UNITED STATES
DEPARTMENT OF THE INTERIOR
BUREAU OF LAND MANAGEMENT

SUNDRY NOTICES AND REPORTS ON WELLS
Do not use this form for proposals to drill or to re-enter an abandoned well. Use Form 3160-3 (APD) for such proposals.

2 Timmy

Re: Permanent Abandonment

Timmy # 2

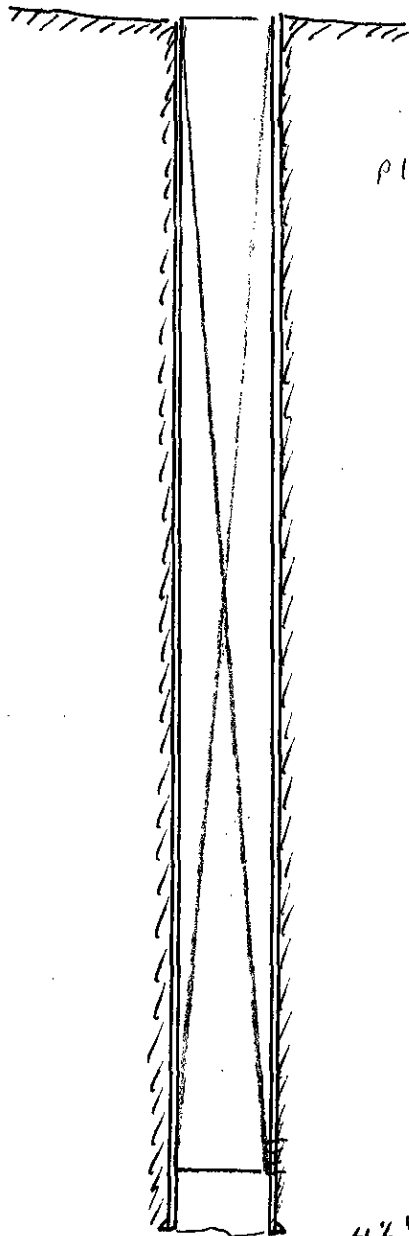
1. Plugging operations authorized are subject to the attached "General Requirements for Permanent Abandonment of Wells on Federal and Indian Lease."
2. Farmington Office is to be notified at least 24 hours before the plugging operations commence (505) 599-8907.
3. The following modifications to your plugging program are to be made:
 - a) After plug has set, tag top of cement and refill casing with cement if necessary.
